Product Change Notice

Notice: #100729 Date: July 29, 2010

Description:

New Full Size Mechanical Drawing

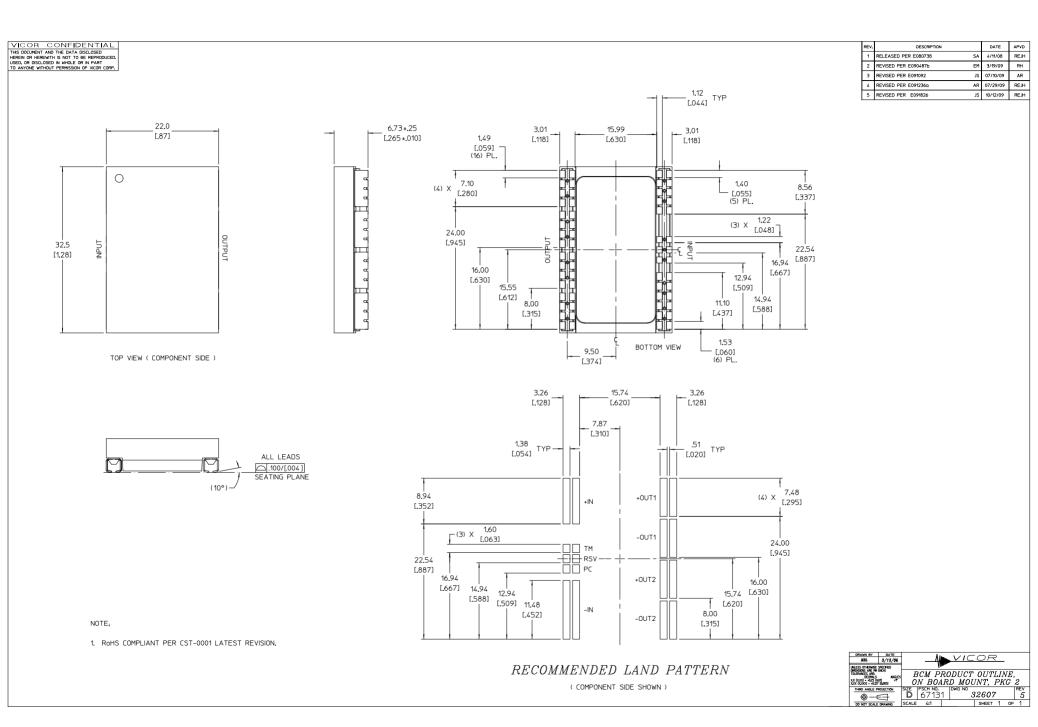
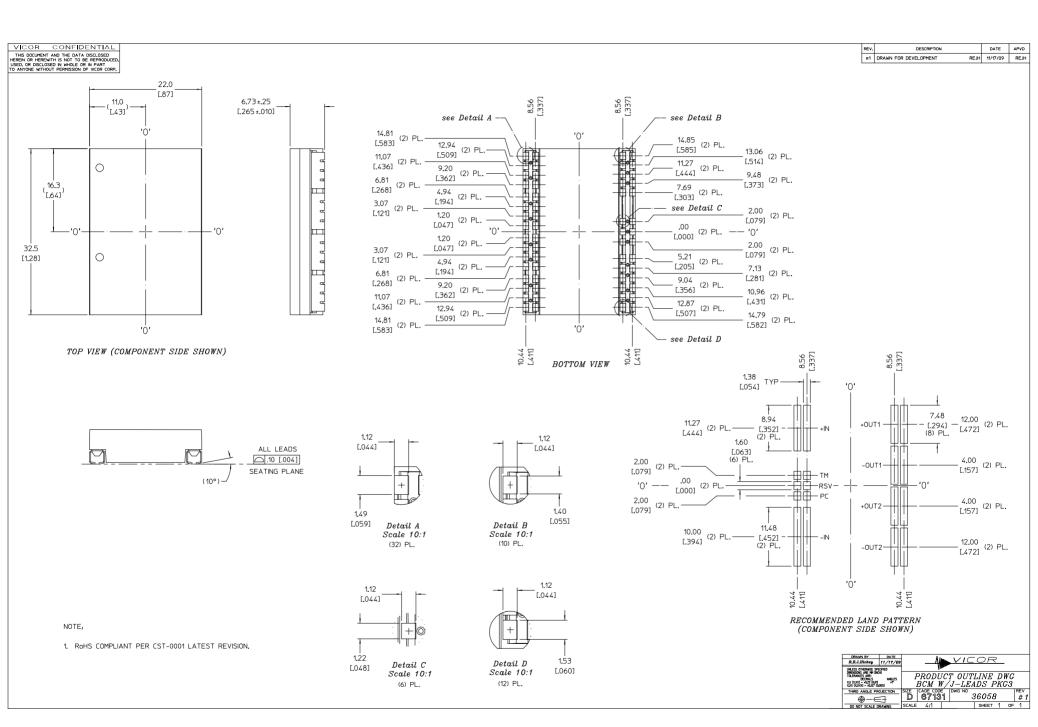
As part of the increase in V•I Chip capacity, we are qualifying new package molding equipment and a new panel array layout. In our original 16 –up (4.464" x 8.273") array, the mold compound flowed from the center outward over individual circuits. In the new 16-up (3.110" x 7.559") array, the mold compound flows from the edge over two circuits which are individually sawn. There are no changes to the external dimensions of the package. However, there will be a small change to the underside of the package that you may notice upon careful examination (see table). As there are no changes to materials or V•I Chip circuitry, there are no expected changes to thermal, mechanical or electrical performance of the parts.

As there is no change to the external dimensions or PCB footprint, no interference fit issues are expected. However, you may like to check that the new package does not interfere with components in close proximity to existing V•I Chip products.
